Council Agenda Report

Subject: Appeal No. 20-009 - Appeal of Planning Commission Resolution No. 20-46 (29623 Cuthbert Road; Owner/Appellant, Colby Family Trust)

RECOMMENDED ACTION: Adopt Resolution No. 20-48 (Attachment A), determining the project is categorically exempt from the California Environmental Quality Act (CEQA); granting Appeal No. 20-009 (Attachment B) and approving Coastal Development Permit (CDP) No. 19-005 to allow for a new single-family residence, second unit, swimming pool/spa, and onsite wastewater treatment system (OWTS), including Site Plan Review (SPR) Nos. 19-072 and 20-013 for construction of the residence and second unit above 18 feet in height, and Minor Modification (MM) No. 19-010 for a 13 percent reduction of the rear yard setback to replace a home destroyed in the 2018 Woolsey Fire, located in the Rural Residential-Two Acre zoning district at 29623 Cuthbert Road (Colby Family Trust).

Figure 1 – Proposed Site Plan and Previously Existing Development Footprint

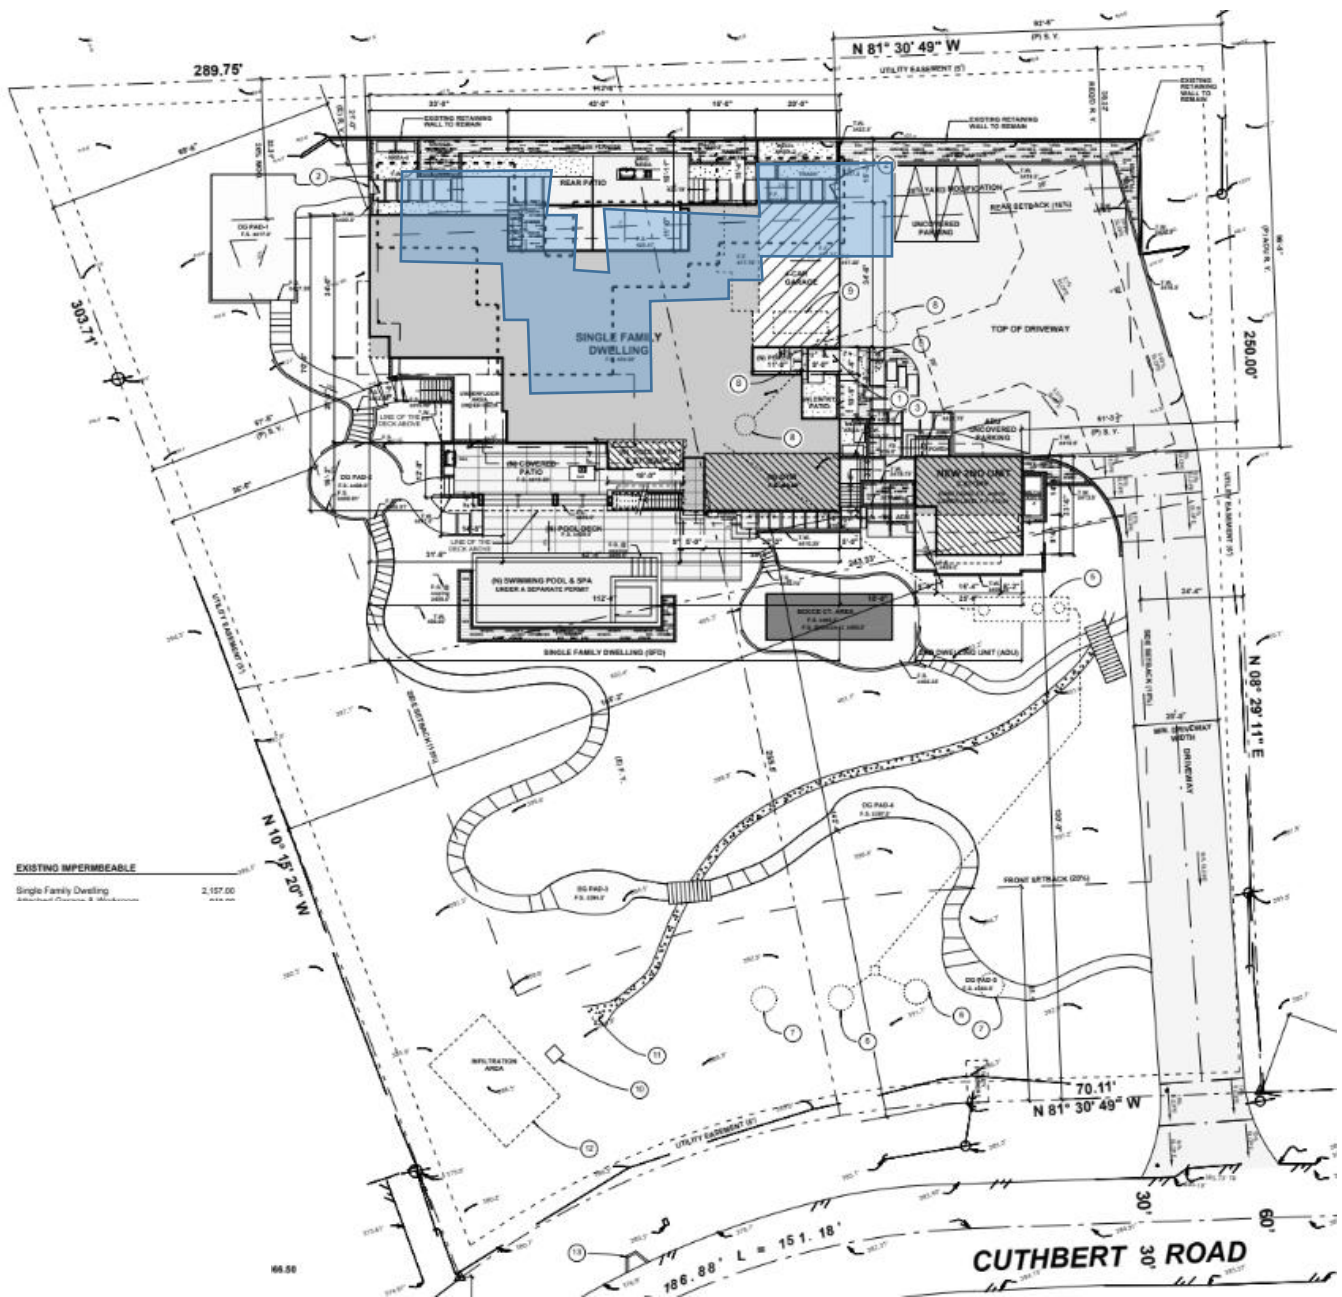
APPEAL ITEM 1B: *Planning Commission Finding 1 - "The proposed development is not consistent with LIP Section 3.6(F)(6) or MMC Section 17.40.040(A)(6)(f) because the 100-foot setback from the parkland containing Environmentally Sensitive Habitat Area to the north has not been provided."*

This finding is not supported by the evidence. The Planning Department informed the commissioners that according to the LCP ESHA and Marine Resources Map the ESHA was approximately 120 feet to the north on the parcel owned by the State. It was determined that there was no impact to recreation opportunities or ESHA so a 100' setback is not required. The house not only does not violate any ESHA buffer, but the homeowners and architect had increased the setback from a distant ESHA zone so as to be even further away from the distant ESHA zone.

In addition, the proposed replacement structure is 12 feet, 4 inches further from the rear property line than the previous residence, so a greater setback is being provided, increasing the distance of the fuel modification area from the ESHA compared to what had taken place in the past. A variance from the parkland setback requirement of LIP Section 3.6(F)(6) is not required.

Figure 2: Two-Thirds Exhibit

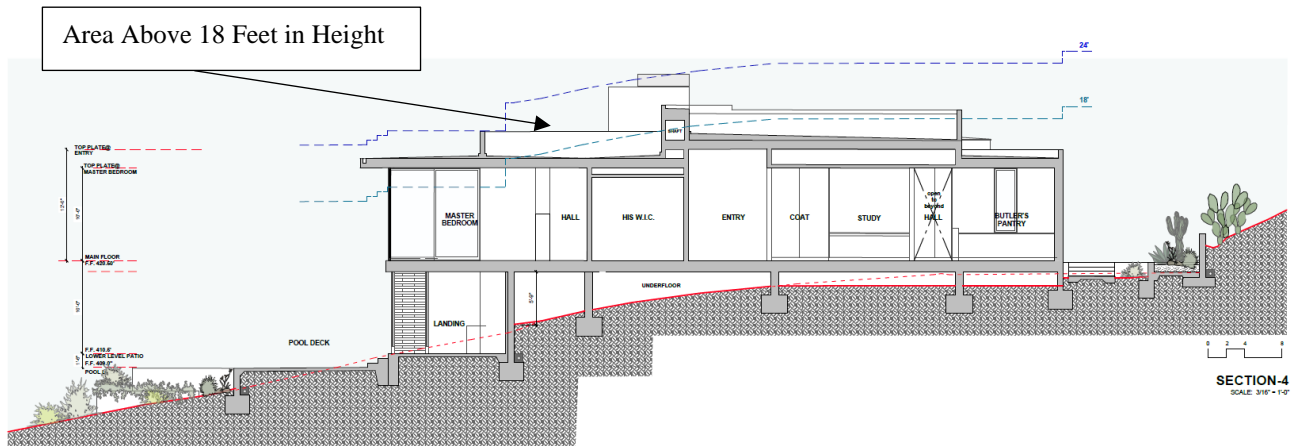
APPEAL ITEM 1A: *"Planning Commission Finding 1 - The project fails to comply with the Local Coastal Program or Malibu Municipal Code (MMC). Specifically, the architectural plans do not comply with the two-thirds rule (Local Implementation Plan (LIP) Section 3.6(K)(2) or MMC Section 17.40.040(A)(13)(b)."*

The finding is not supported by the evidence. The Planning Department confirmed in the staff report that the project does comply, and no evidence was presented to the contrary by the Planning Commission. Also, the project architect provided additional documentation to the Planning Department showing that only a minor portion of the building is 2 stories high and the rest of the area over 18' in height is due to a high ceiling and not to a 2nd story (floor area where you can stand), confirming that the project does comply.

As shown in Table 3 in the Planning Commission agenda report (Attachment C), the proposed TDSF for the project is 7,732.5 square feet. That area is comprised of the proposed structure, garage and second unit. Since both the residence and second unit involve construction over 18 feet, both were evaluated for two-thirds rule compliance. The first-floor area and the portion of the proposed residence below 18 feet totals 6,173 square feet. According to both the LCP and MMC the allowable second floor and the portion of the proposed residence above 18 feet could be up to 4,115.33 square feet in size. The project proposes 3,358 square feet of second story and portions of the building above 18 feet in height and therefore, meets the two-thirds rule. The area of the second unit below 18 feet is 542 square feet and the area above is proposed to be 357 square feet or exactly two-thirds.

Compliance with LIP Section 3.6(K)(2) and MMC Section 17.40.040(A)(13)(b) is visually demonstrated by the applicant and included in the project plans including Sheet A-1.4 entitled Two-Thirds Attachment (Figure 2). This design was chosen because it complements the site's topography by following the contours of the descending slope of the site visually lowering the overall profile of the house. Furthermore, the proposed design provides for lower building massing than a traditional two-story design.

The Planning Commission, following a new interpretation of the two-thirds rule it had adopted in denying a CDP application for a new residence at 33608 Pacific Coast Highway, based the denial on finding that the covered patio areas of the main residence should not be included in the two-thirds calculation of the main residence and that instead only the interior floor area should have been utilized in the calculation. The hearing on the instant Project occurred before the July 13, 2020, City Council meeting where the Council overturned the Planning Commission's decision on the 33608 Pacific Coast Highway project and upheld the City's longstanding interpretation that covered areas that extend greater than six feet must be counted for TDSF and two-thirds rule calculations. This interpretation has been consistently applied by the City except for a one-year period in 2008. The consequence of not counting these covered areas could allow for owners to create large covered areas to their homes which would expand with few limits and would add to the bulk and mass of a structure. Such actions would be conflict with TDSF limitations which are designed to limit the size of structures. Under this standard, as described above, the Project complies with the two-thirds rule.⁵

Figure 5 – Aerial Photograph of Adjacent Properties

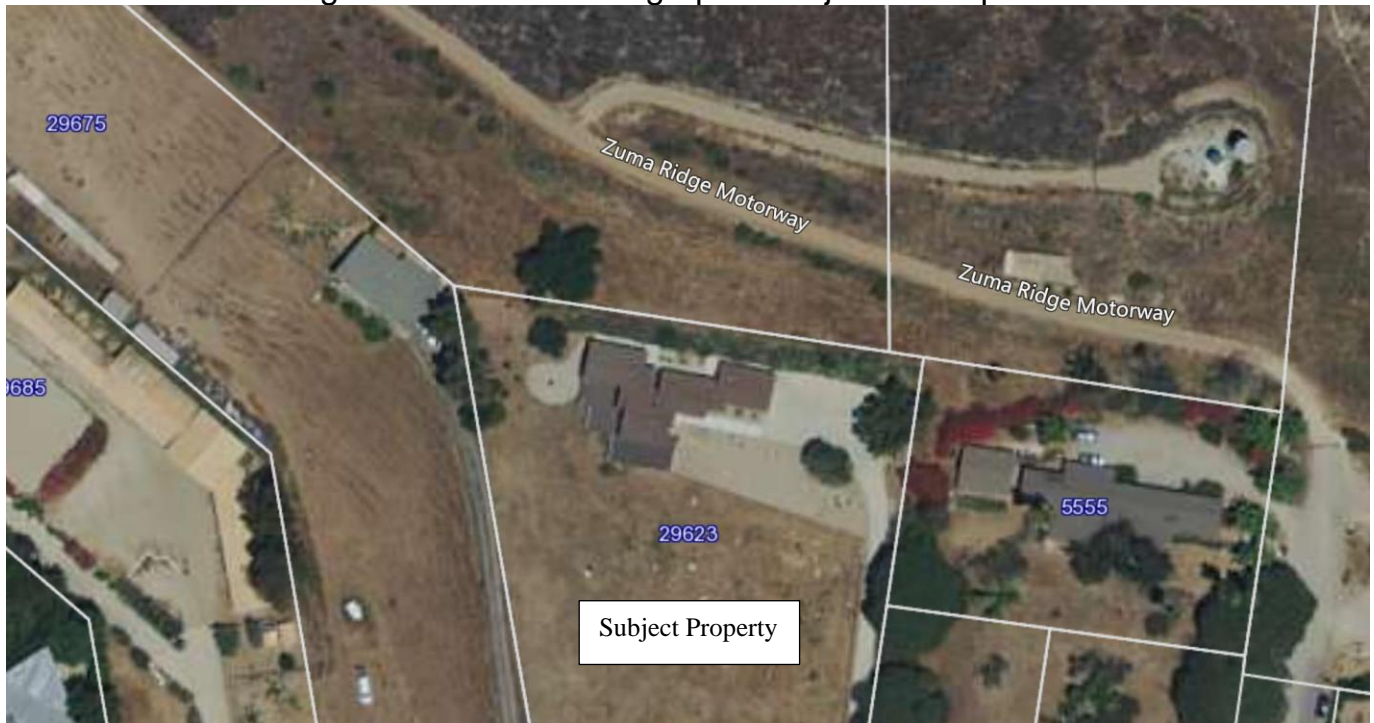
APPEAL ITEM 3: *Planning Commission Finding 3 – “All of the required findings to grant the minor modification to reduce the rear yard setback cannot be made. Specifically, given the size of the parcel, alternative building pad locations are available that do not require a reduced rear yard setback.”*

The project proposes a 13 percent reduction of the rear yard setback required by LIP Section 3.6(G)(1) from the required 38 feet, 4 inches to 33 feet, 4 inches. The previously existing residence that was destroyed by fire had a nonconforming rear yard setback of only 21 feet. So, while the new replacement residence is proposing a minor modification for the rear yard compared to the *required* rear yard setback, this will actually result in the residence being 12 feet, 4 inches *further* from the property line than the original residence. The minor modification allows the project to minimize site disturbance by utilizing the previously existing driveway and required fire truck access, so additional grading is avoided, while increasing the rear yard setback compared to the original home. Furthermore, the increased rear yard setback also increases the distance between the proposed residence and the parkland and trail adjacent to the subject property. Adjacent properties also have reduced setbacks and have historically been built in-line with each other to maintain views (Figure 5). In addition, other building pads in the area also have reduced rear yard and other setbacks, so it is not anticipated that the proposed development will adversely affect neighborhood character (See Figure 3 for pre-fire aerial).

The Planning Commission concluded that given the size of the parcel the house could be moved further away from the rear property line while staying within the existing development pad. While the project could be re-sited to another location on the subject parcel, the proposed improvements are sited on previously disturbed areas on the property to utilize the existing access to the site.
